BILLING CODE 6712-01-P**DEPARTMENT OF TRANSPORTATION****National Highway Traffic Safety Administration****49 CFR Part 571**

[Docket No. NHTSA-2005-23439]

RIN 2127-AJ65**Federal Motor Vehicle Safety Standards; Tires****AGENCY:** National Highway Traffic Safety Administration (NHTSA), Department of Transportation.**ACTION:** Final rule; response to petitions for reconsideration.

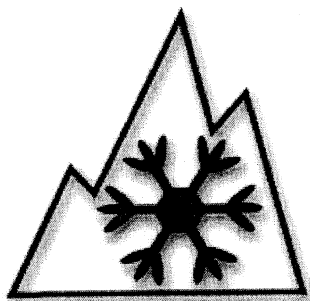
In order to enable the agency to ascertain which tires are to be tested at 110 km/h, the agency is adding a labeling requirement to all PC snow tires and LT snow tires with load ranges of C, D, and E that are certified at this test speed. The manufacturers must mark their snow tires with the Alpine Symbol if they wish to certify their snow tires to the special requirements applicable to snow tires. The use of the Alpine Symbol will have the added benefit of enabling consumers to identify snow tires that provide a higher level of snow traction compared to all-season tires. However, the tire manufacturers are not obligated to do so if they wish to certify their snow tires to the normal requirements of the Standard. Thus, only the snow tires certified to the reduced test speed requirements must display an Alpine symbol (as shown below), on at least one sidewall. The symbol is currently required in Canada as a means of identifying snow tires.

If the manufacturers choose to mark their snow tires with the Alpine Symbol, the mountain profile must have a minimum base of 15 mm and a minimum height of 15 mm, and must contain three peaks with the middle peak being the tallest. Inside the mountain profile, there must be a six-sided snowflake having a minimum height of one-half the tallest peak.

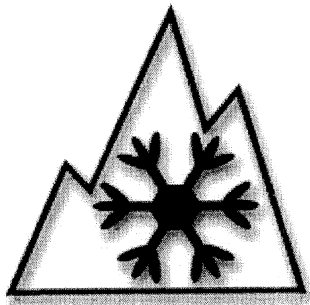
(i) *Alpine Symbol*. A tire meeting the definition of a snow tire as defined in paragraph S3 may, at the option of the manufacturer, show the pictograph of a mountain with a snowflake as shown below. If the manufacturer chooses to mark the snow tire with the alpine symbol, the mountain profile must have a minimum base of 15 mm and a minimum height of 15 mm, and must contain three peaks with the middle peak being the tallest. Inside the mountain, there must be a six-sided snowflake having a minimum height of one-half the tallest peak.
